From: Rosemary Roach [redacted]  
Sent: 22 May 2023 09:47  
To: [redacted] [consultations@noturalengland.org.uk](mailto:consultations@noturalengland.org.uk)  
Cc: Clare Adamson [redacted]; 'Jane Murray [redacted]'; Sharon Finch [redacted]  
Subject: Elmbridge planning application no. 2022/3796 - site at 16-18 Oatlands Drive, Weybridge

# Comments and Questions about the Revised Biodiversity Matrix for PA 2022/3796

These comments and questions relate to the Cover Letter from AA Environmental Consultant [REDACTED] submitted as an Amended Document, accompanying the Biodiversity Matrix 3.1, for the above planning application.

Image 2 - photo of 16 and 18 from satellite images.

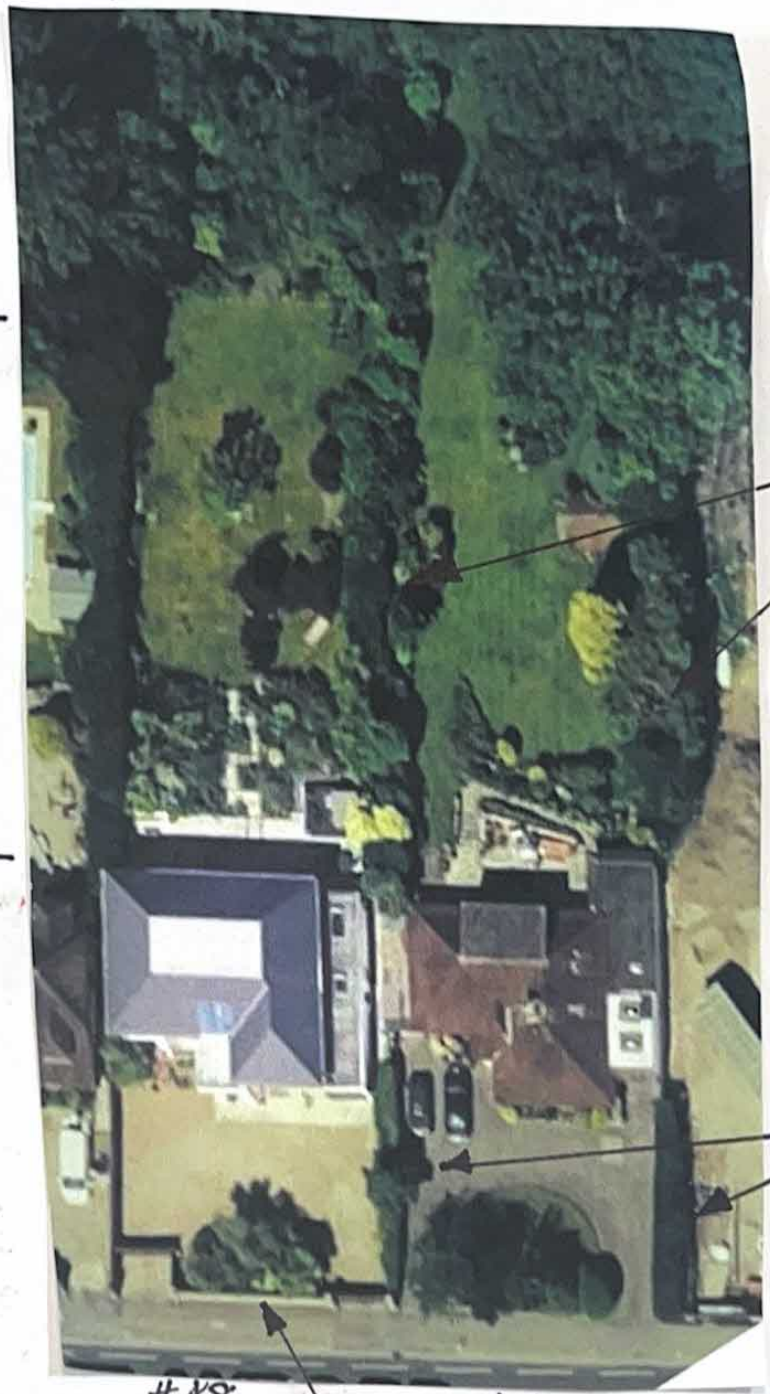
The revised plan (Image 1) now shows the pond, **but still does not show:**

- the **FULL** 48m long, thick hedge between #18 and #20 Oatlands Drive, just a misleading thin green line. Also the hedges between #16 & #18 and #16 & #14 appear much shorter on the plan than in the photo (see Image 2 of satellite images.)
- the semi-circular border of Vegetated Garden in the front garden of #18 (see Image 2 below)
- the hedges currently in the front gardens of #16 and #18 Oatlands Drive (shown in Image 2.) These should also count towards Vegetated Garden and/or Hedgerow. We assume the developer plans to remove these if the application is granted as they do not appear in the Proposed Habitats Plan (Image 3)

Border between #18 & #20

Further 11m of trees and bamboo border

Privet hedge  
48m long  
5-6m high  
approx 2.5m wide

Other 2 hedges appear much longer than shown on Existing Habitats Plan.

Both hedges in the front gardens of #16 & #18 have been omitted from the latest Existing Habitats Plan.

The green semi-circular border in the front garden of #18 is still missing.

Firstly, as demonstrated in the 3 images above, they have not counted the 2 existing approx 14m long and 2 to 3m high hedges currently in the front gardens of #16 & #18 that can be seen in image 2. They have also shown the hedges between #16 & #18 and #14 & #16 as considerably shorter than they actually appear to be in the satellite images.

Image 3: The Proposed Habitats Plan, showing removal of front hedgerows.

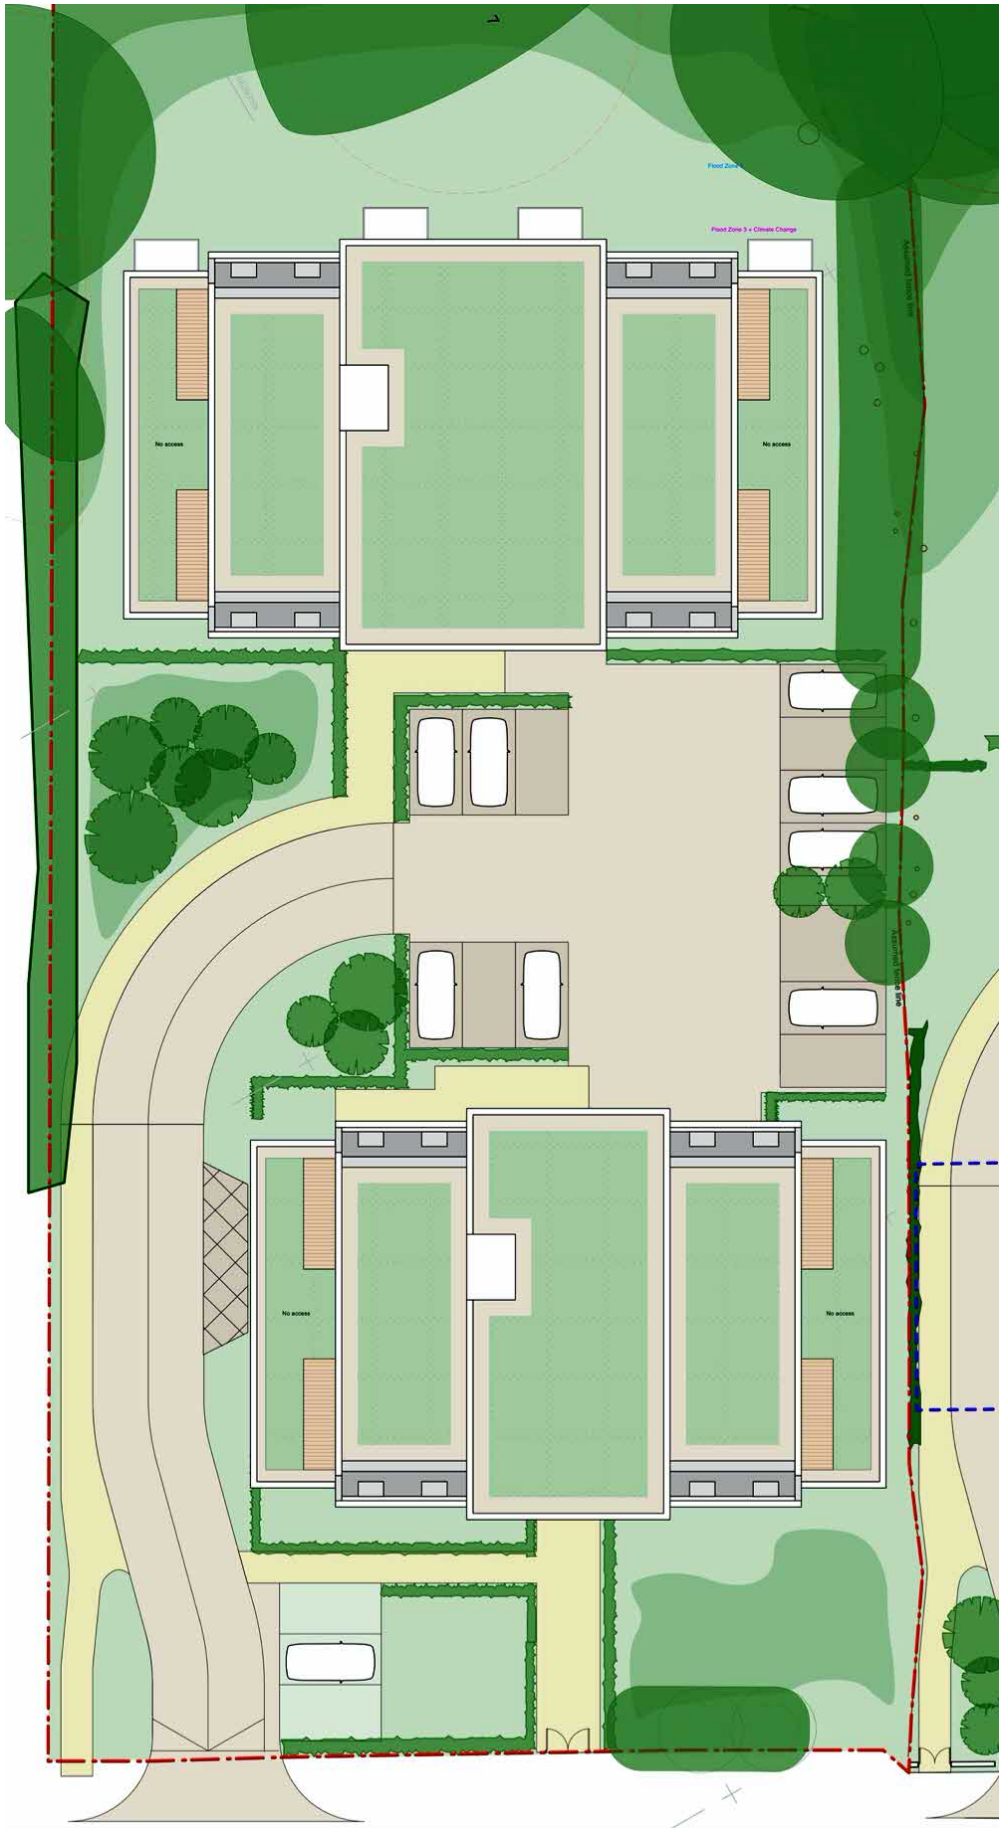
The table in their document suggests that the existing gardens have only 0.977 ha of trees and the proposals would deliver 1.118. The image 2 of the current gardens vs image 3 of the proposed habitats would make this surprising.

The Proposed Habitat Plan in image 3 shows many trees of varying sizes being planted on the left hand side near the car park / entrance driveway.

The table says there would be 2 new medium and 11 medium small trees. But the 2 spaces that these trees are drawn in on the plans measure approximately 10m by 4m, and one quarter of a circle of radius 6m. So there is no way that they could support more than 2 or 3 trees in total.

Image 3 (repeated)  
Roof plan used in biodiversity matrix

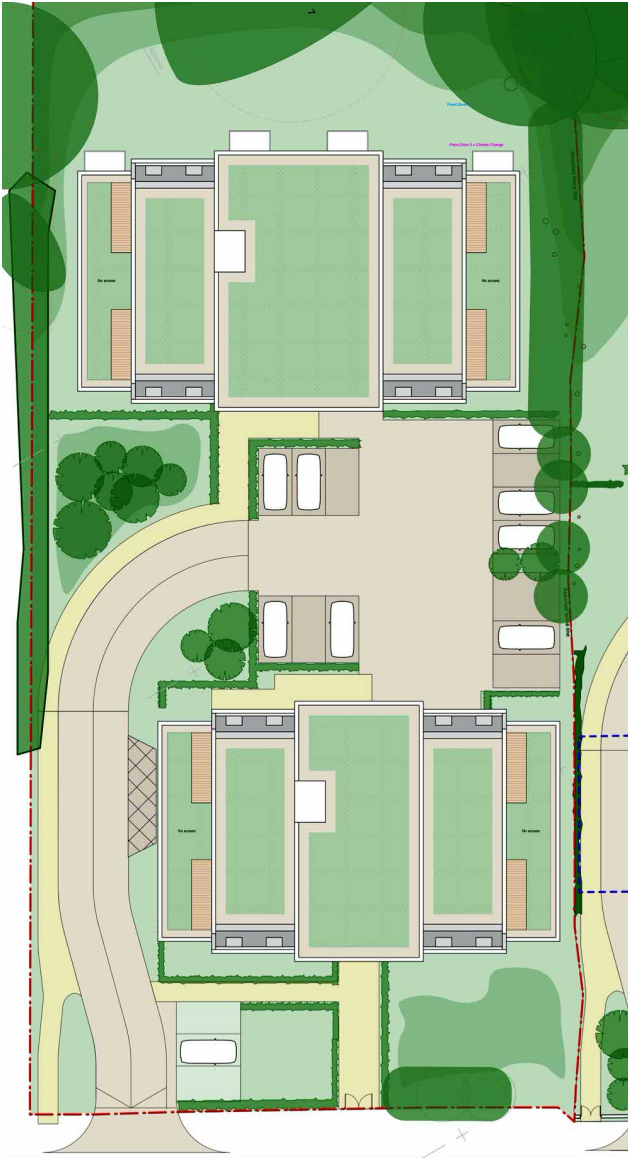
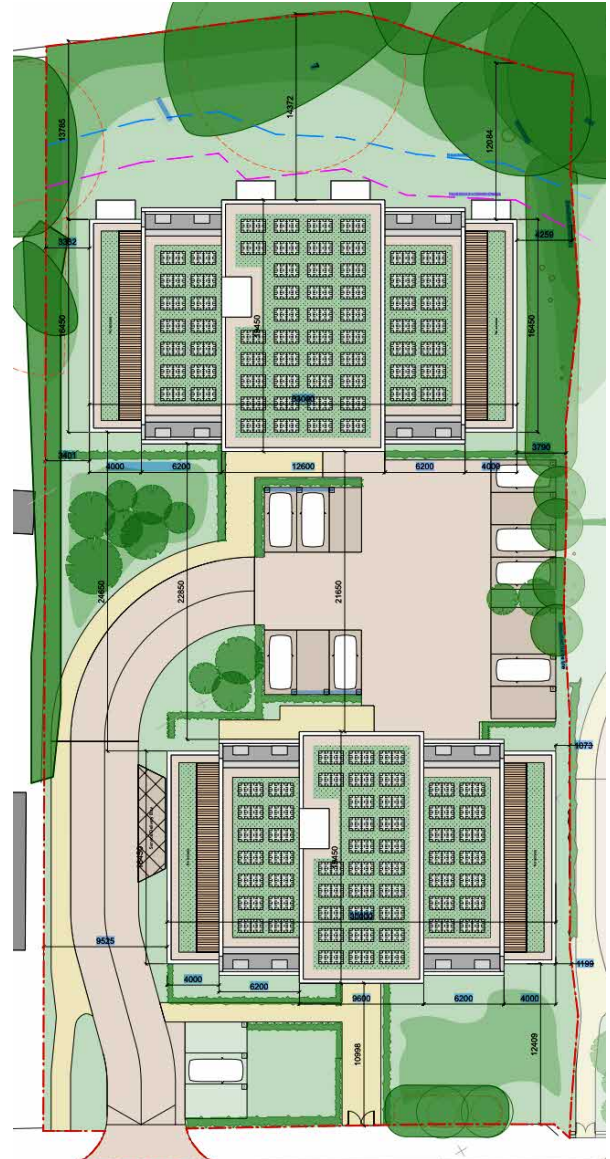
Image 3 is repeated below, showing the roof plan according to AA Environmental Consultants used for the Biodiversity Matrix, next to image 5 which is the roof plan as it appears in the actual planning application, for comparison purposes:

In the planning application (Image 5), the majority of the side sections of roofs are used for roof terraces and amenity space for the proposed flats. They also show solar panels covering significant amounts of the remaining roof space. So, Image 3 (Biodiversity Matrix) and Image 5 (Roof Plan in Actual Planning Application) show very different roof plans. The use of this space is vague and contradictory as either green, or resident amenity, or solar panelling.

Apart from these pictures, there is no detail about green roofs in the Design and Access Statement. There is nothing in writing to commit to these roof spaces or explain exactly what they are and how they would be maintained.

So we are concerned that it is these green roof spaces that currently tip the matrix into a positive, given the lack of clarity on what they are and how much space they will take up.
